PLANNING APPLICATION REF 2014/5117/P

A geotechnical and structural assessment of a basement planning application 2014/3668/P and its potential impact on Nos. 29 and 33 Briardale Gardens

Report reference G1422-RP-01-E1

**Geology and ground conditions in the vicinity of
31 Briardale Gardens, London, NW3 7PN**

Figure 2

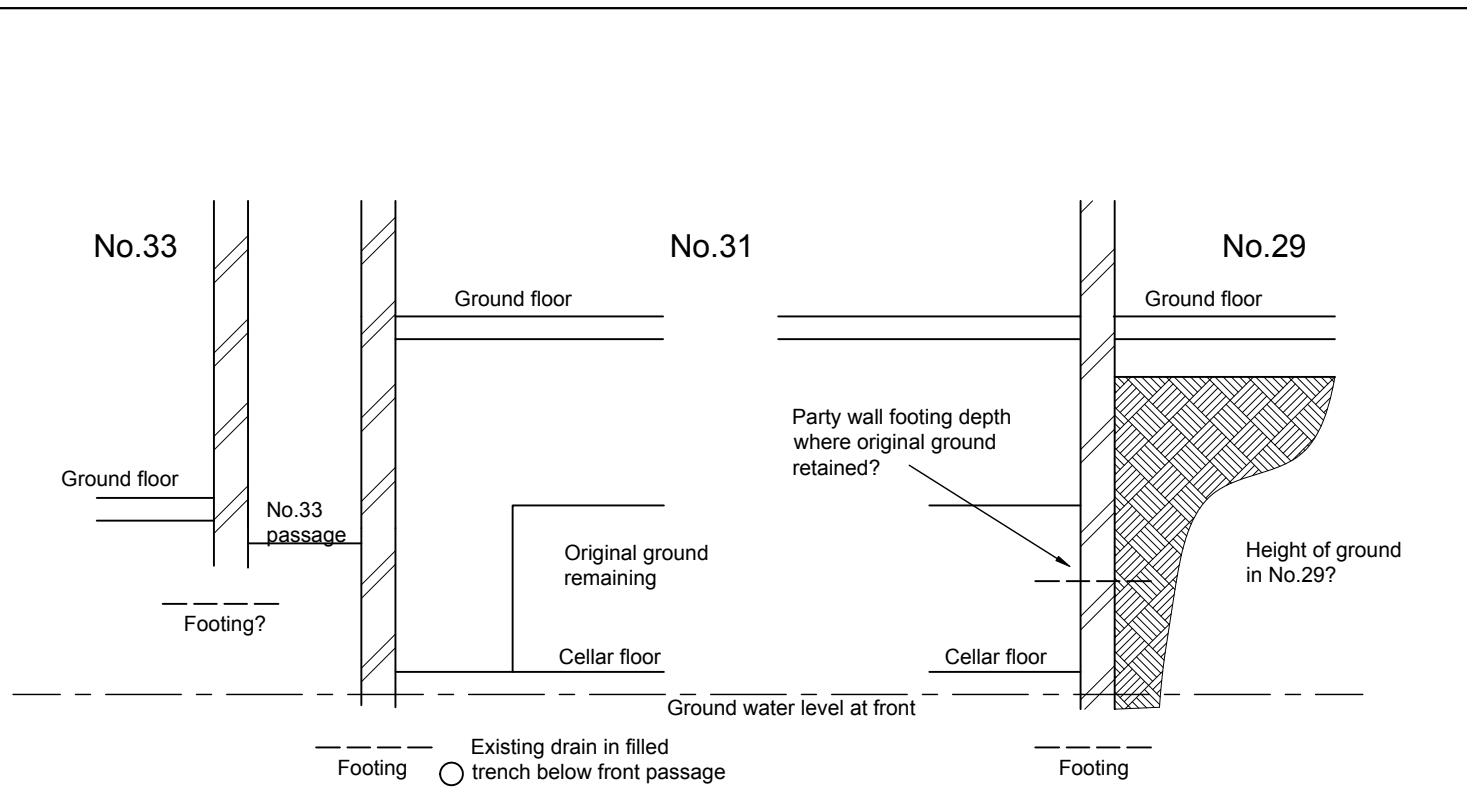
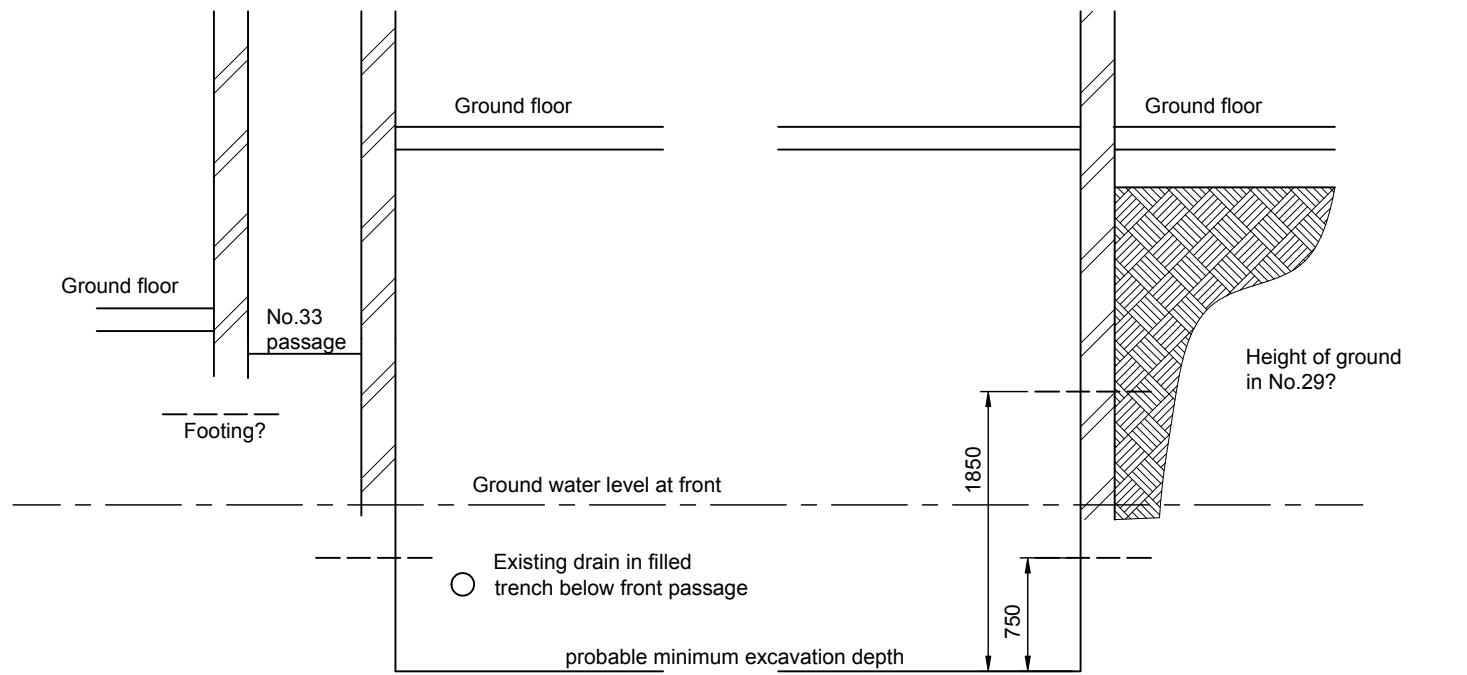
18. Figure 2 gives an approximate sketch section of the existing and proposed situations at the 29/31 and 31/33 boundaries.

Project Ref. G1422	Project Title. 31 BRIARDALE GARDENS NW3 7PN	Indicative North
Sheet Ref. Figure 5	29 BRIARDALE GARDENS 1937 REAR EXTENSION

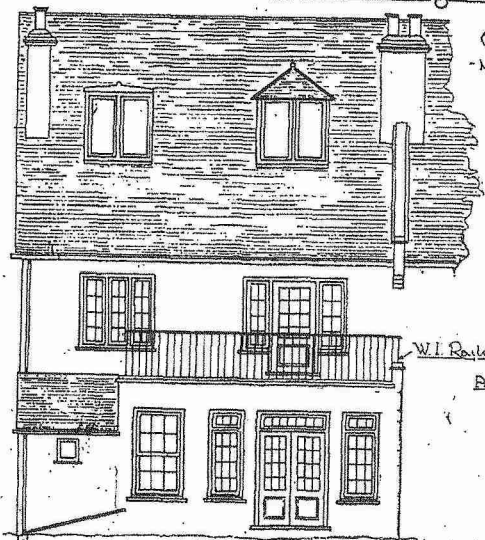
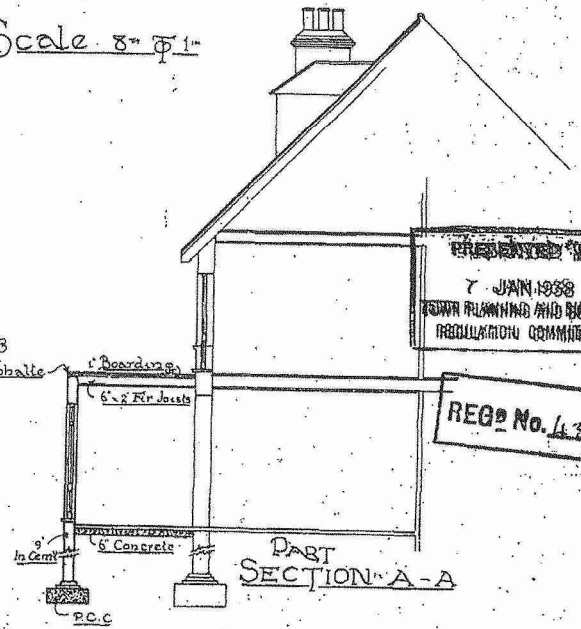
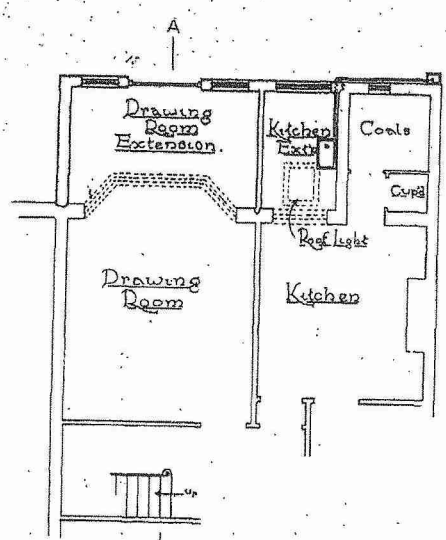
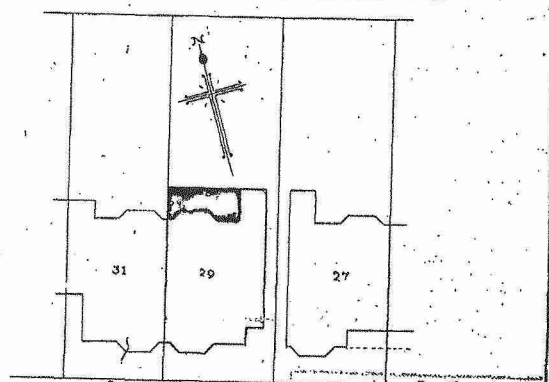
- (xviii). A planning drawing (Figure5) prepared in 1937 for the rear extension of No 29 by builders based in Finchley Road suggests that they might have expected the foundation to be deeper than normal shallow strip footings.

Extracts 1 & 2: Plans within the Basement Impact Assessment by Mann Williams Consulting Civil and Structural Engineers (Date: June 2014 ref: 7060) and subsequent amended assessment

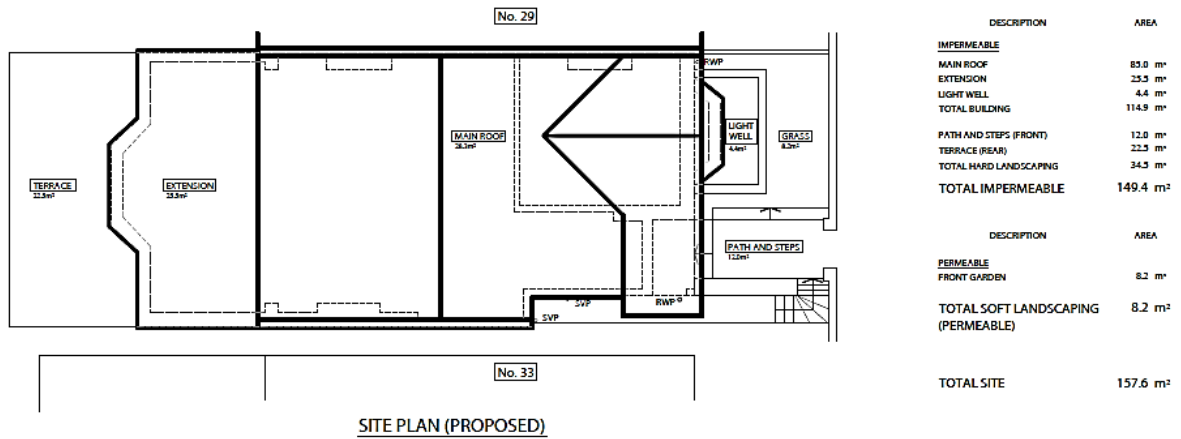
5.1.1 The national policy guidance on permitted development rights and Camden's own Guidance in CPG4 is clear in that such rights will be withdrawn if trees are effected by the basement proposals. Furthermore, CPG4 specifically identifies that such impacts include construction within the RPZ (paragraph 2.67). The extracts below from the original and recently revised structural design document notes that the extension foundations will be 'stepped down' to basement level, adding underpinning of the neighbouring boundary wall within the RPA:

- 5.1.2 This inextricably links the basement to the extension proposals, along with the proposed breaking out and filling in of the existing steps down to the basement.
- 5.1.3 The additional information provided by ATS does not address the concerns raised over the protection of this tree. In summary, the main omissions are as follows:
- The impact of the foundations noted for the proposed extension, which highlighted as being stepped down to basement level; this excavation would occur within 1m of the stem of the Magnolia Tree T1 (see Extracts 1 & 2 above).
 - The impact of the proposed underpinning of the party wall within the RPA of T1, which has not been addressed in the revised arboricultural impact assessment.
 - The omission of mitigation for the proposed terracing within the RPA of T1, which should be no-dig and permeable (see Extract 3 below).

Extract 5: Extension should be indicated on AIA plan

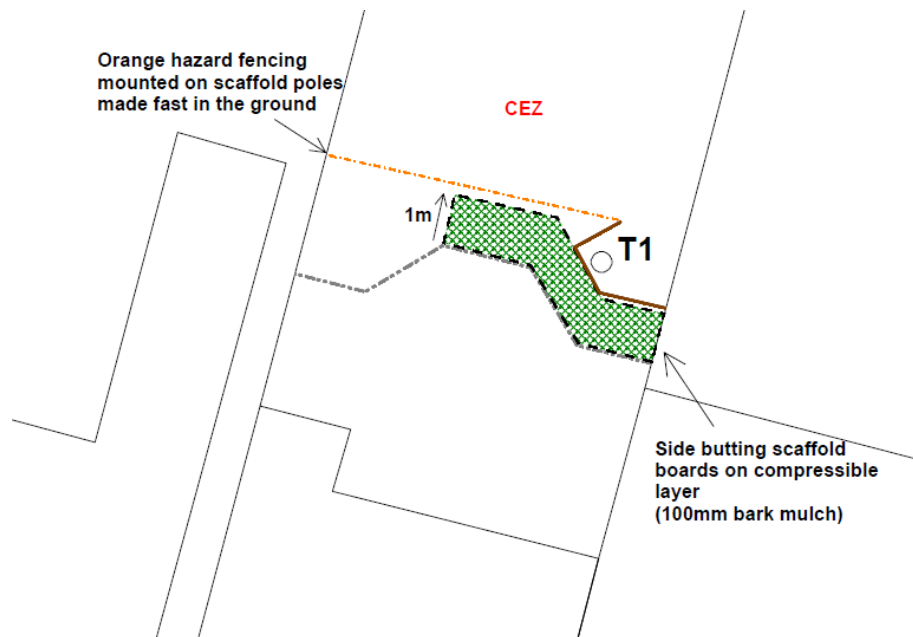
- The inadequate trial pit information. Whilst it is clear that there are very few roots, there is no plan showing how the pit relates to the RPA and it is not situated on the edge of the patio (where the extension foundations are going down to basement level within 1m of the stem as demonstrated in Extracts 1 and 2 above). Therefore further information and more accurate trial pits are required, or details of low invasive foundations. If the proposed foundations are to be dug within 1m of the stem, there will clearly be significant damage to the tree.
- The absence of an AIA plan to BS5837:2012 that illustrates the canopy in full detail and its relationship with the proposed extension. The extract below is the only plan available with the canopy, which should have the extension highlighted.
